CW 7-11 3200 Hackenberry (Irving, TX)

Project Issue Information

Issue Name : Vav's in area 3009 - plans
Description : There are total of 6-boxes VAV that are in open office 3009 & the offices next to area 3010 that have no thermostat located in space
Created By : National TAB **Assigned To :** National TAB - Joe Hertenstein
Status : Open
Priority : Medium **Asset Tag :**
Originated Date : 02/08/2024 - Joe Hertenstein - National TAB

image.jpg

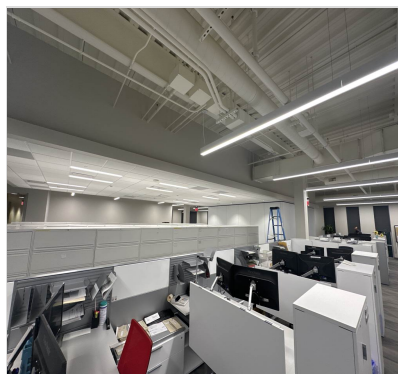
- 02/08/2024 National TAB - Joe Hertenstein
 - Very low actual airflow for these 6 boxes. Dampers all state 100% open in controls but cfm total is 79 CFM for all 6 boxes
